Amphenol Information Communication & Commercial Products (AICC)

Product change notice

Customer		CP/N	FCXXXXX-X
Amphenol P/N	FCXXXXX-X	Date	2021/Dec/30
Change reason	<p>1. Original cable supplier changed MOQ for 1.27mm pitch flat cable (5kms now) which is too large MOQ for us</p> <p>2. We have evaluated alternative flat cable supplier to replace original one, it supports smaller MOQ</p> <p>3. New supplier 1.27mm flat cable is totally compatible</p>		
Change Detail	IDC Socket 2.54mm (pitch between contacts from a same row)	Assembly Process	1.27mm Flat Cable
	No Change (still T812 series)	No Change	Old UL file No.E350147 New UL file No.E524791
Cosmetic comparison:	<p>1. The red line of both flat cable. New one is even more obvious.</p> 		
	<p>2-1. UL file No. printed on cable (Original : E350147, New : E524791)</p>

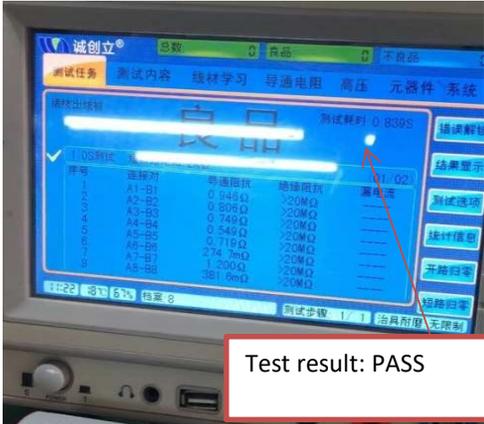
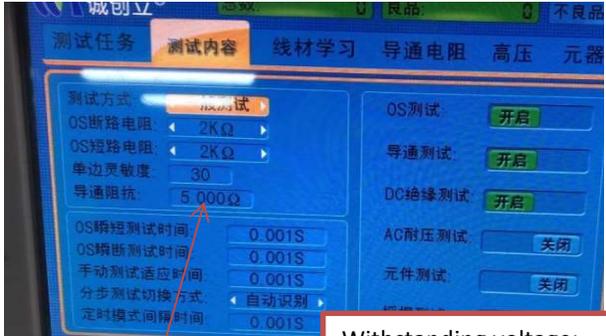
Customer		CP/N	FCXXXXX-X
Amphenol P/N	FCXXXXX-X	Date	2021/Dec/30
Electrical performance verification	<p>Electrical test result are OK for the new flat cable. (Test parameter : withstanding voltage : 300V DC, insulation resistance : 20Mohms, conduction resistance : 5ohms)</p>		
	<div style="display: flex; justify-content: space-around;"> <div style="text-align: center;">  <p>Test result: PASS</p> </div> <div style="text-align: center;">  <p>Conduction resistance: 5 ohms</p> </div> <div style="text-align: center;">  <p>Withstanding voltage: 300VDC; Insulation resistance: 20M ohms</p> </div> </div> <div style="text-align: center; margin-top: 10px;">  </div>

Comment	The new flat cable can replace original one and will not affect function		
Implement date	New flat cable will be purchased from the 17th of January, 2022. There are many stock for old cable and cable assembly, the running change will take about 3~5 month, that depends on demand		
Approved by: RKO	checked by: SGU	Prepared by: EWU
